| Project Title: | Mission Rock Energy Center |
| Document Title: | Data Request Responses Set 1 & 1A to Data Requests 1 through 114 |

Responses to California Energy Commission Staff
Data Requests 1 through 114

Mission Rock Energy Center

Figure DR23-1 (Page 4 of 24)
Land Cover
Mission Rock Energy Center
Ventura County, California

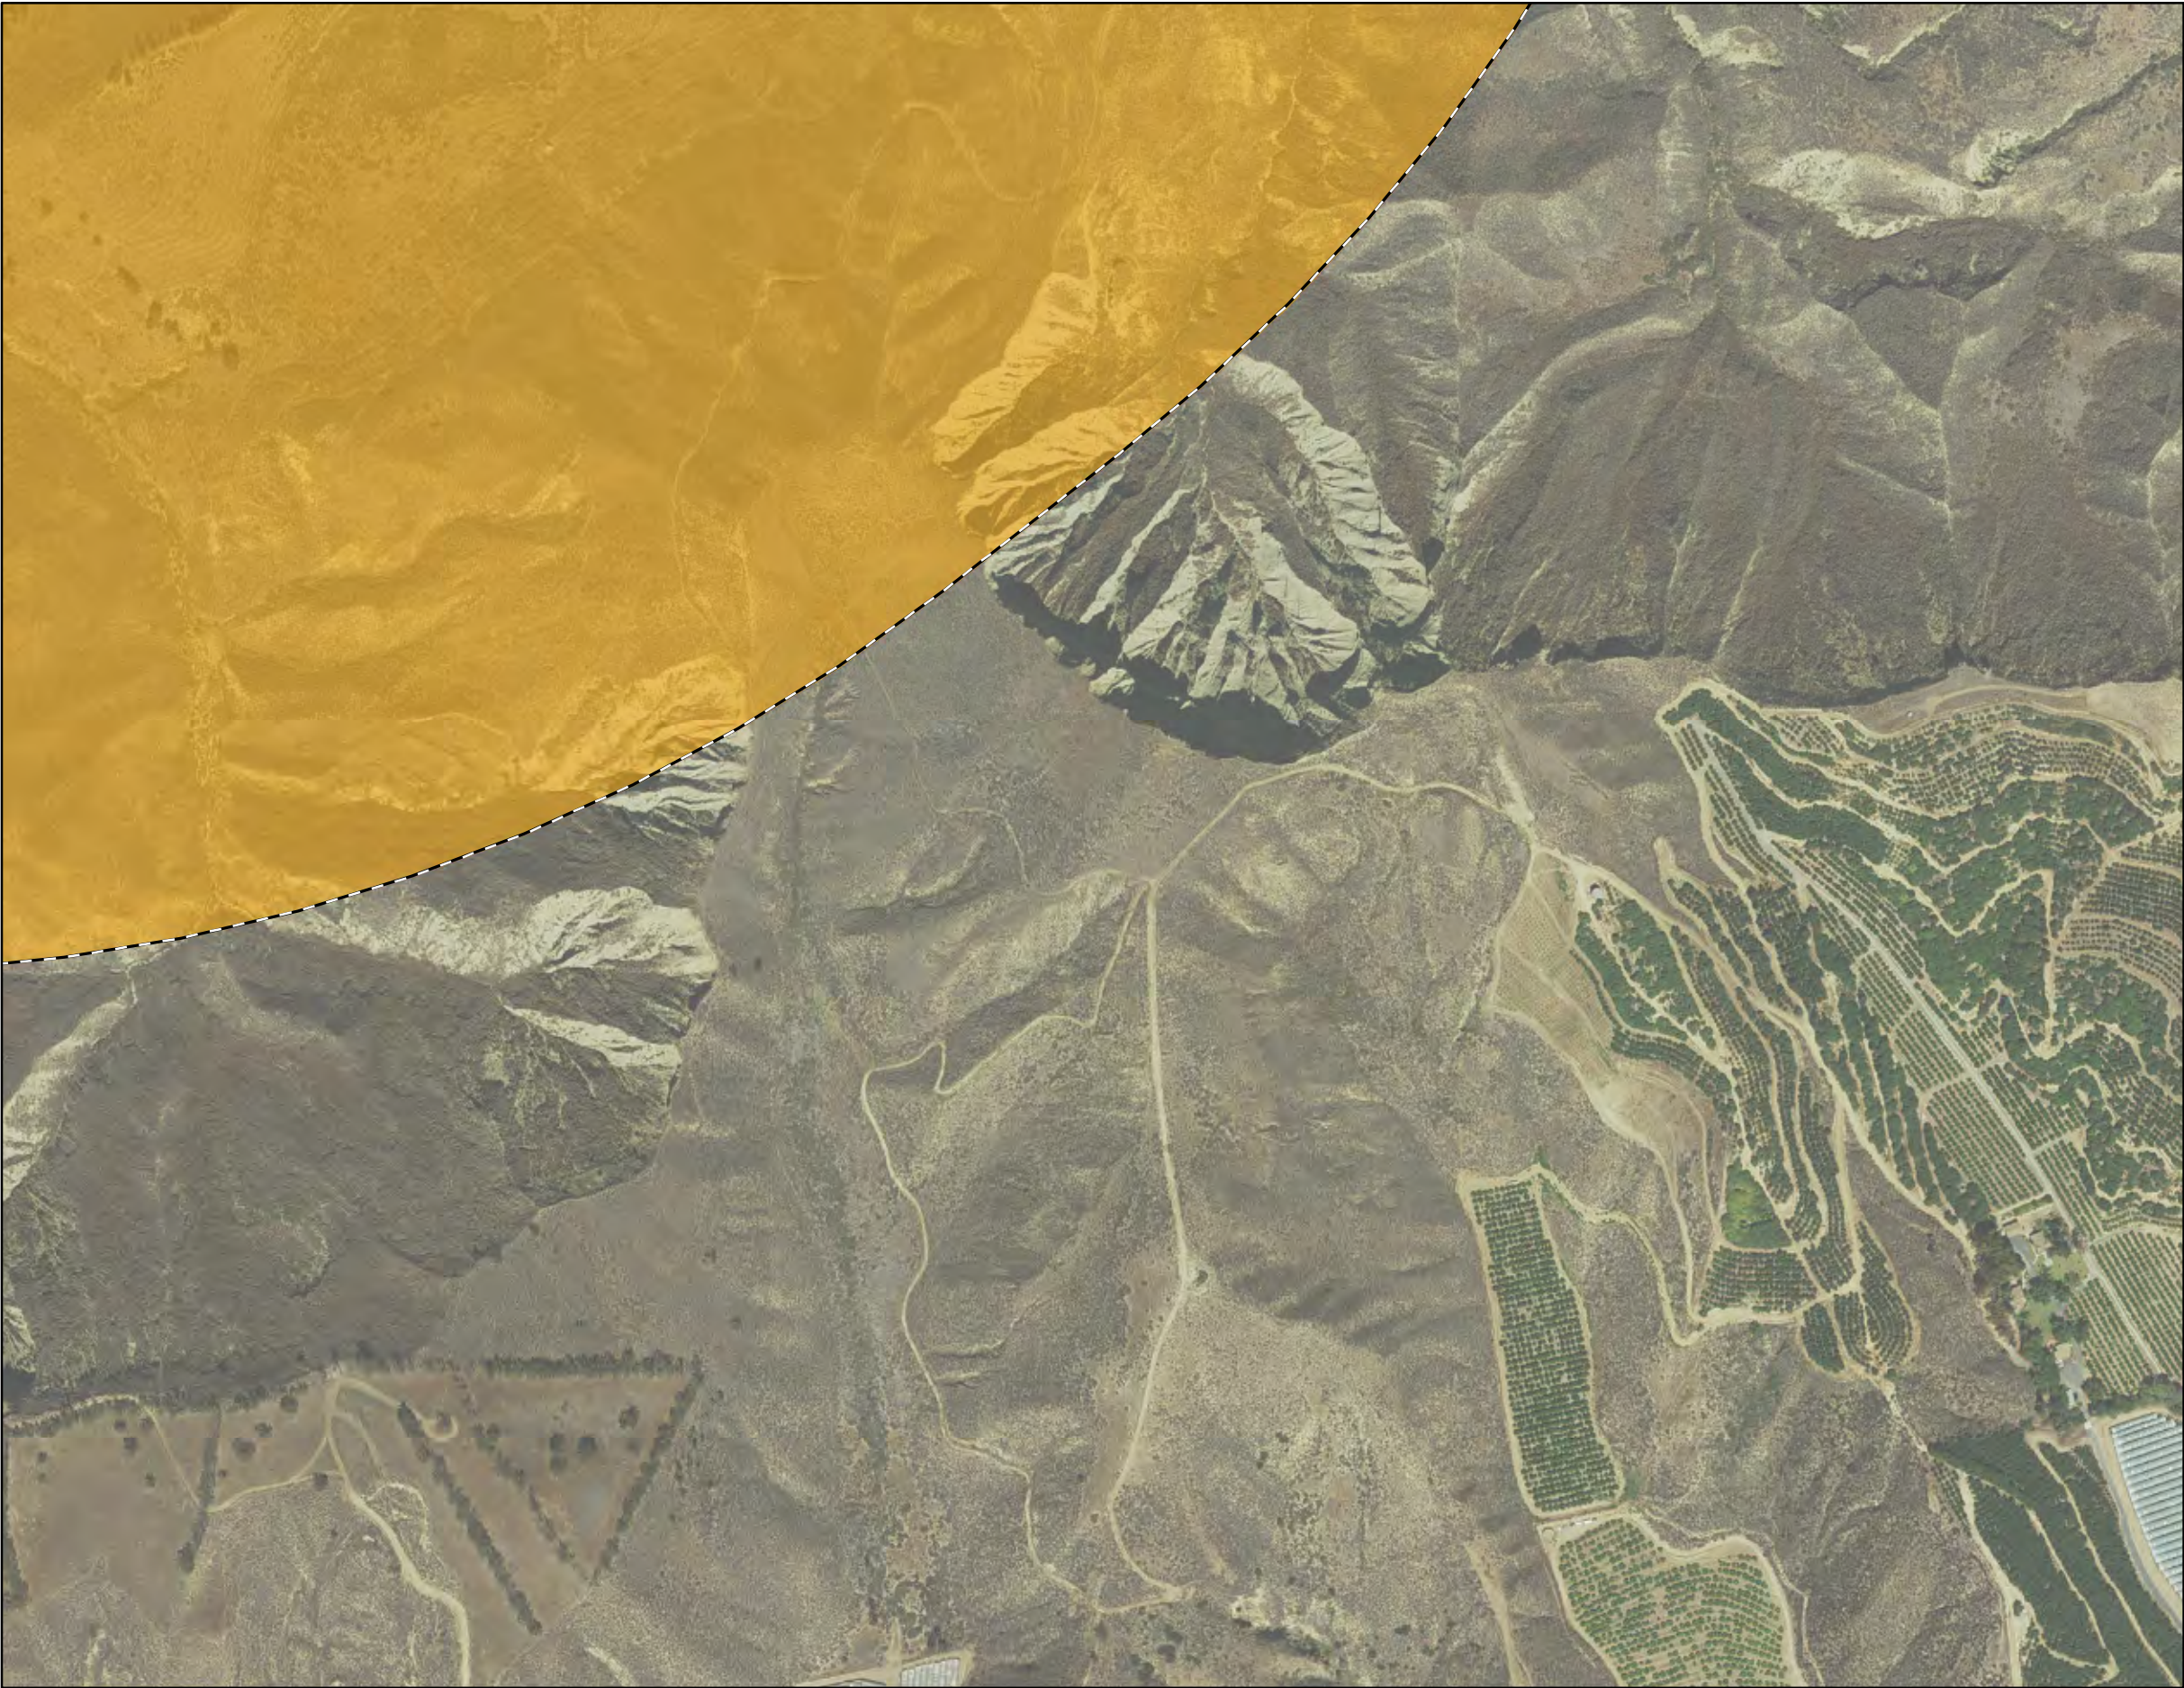
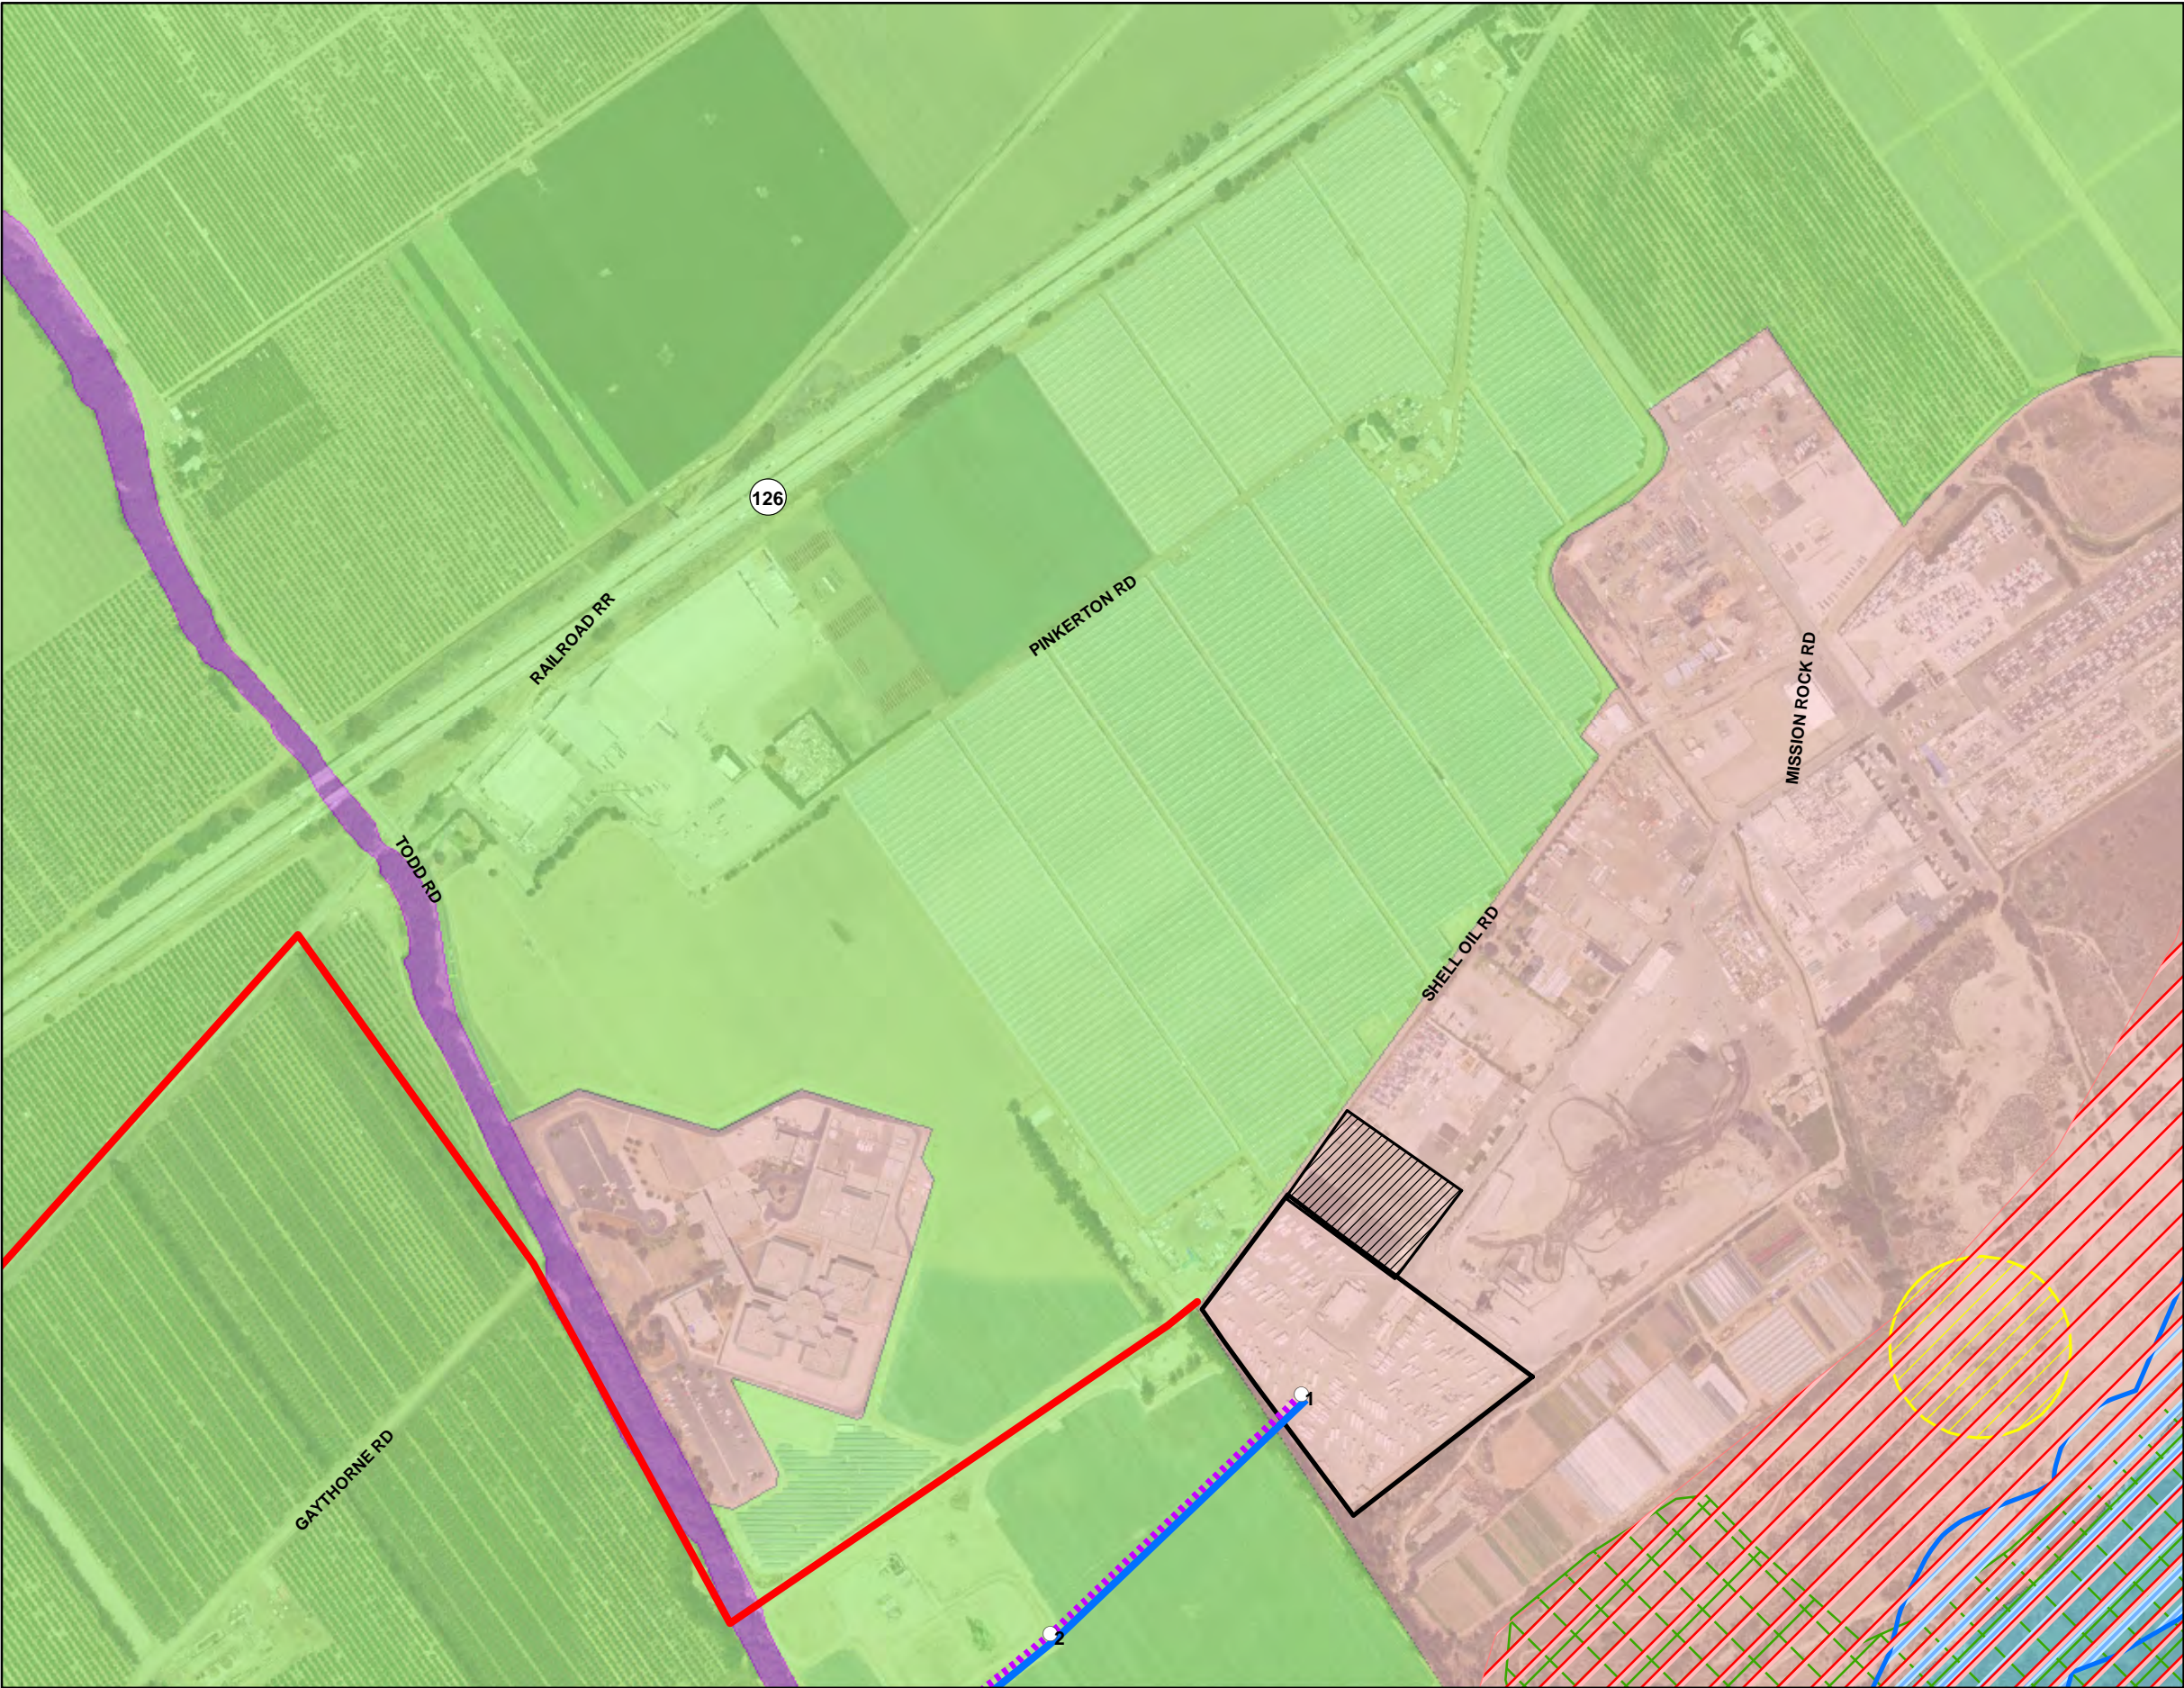
23. *Please revise Figure 5.2-6 to show the areas of riparian habitat.*

Response: Figure DR23-1, showing riparian habitat areas, is attached.
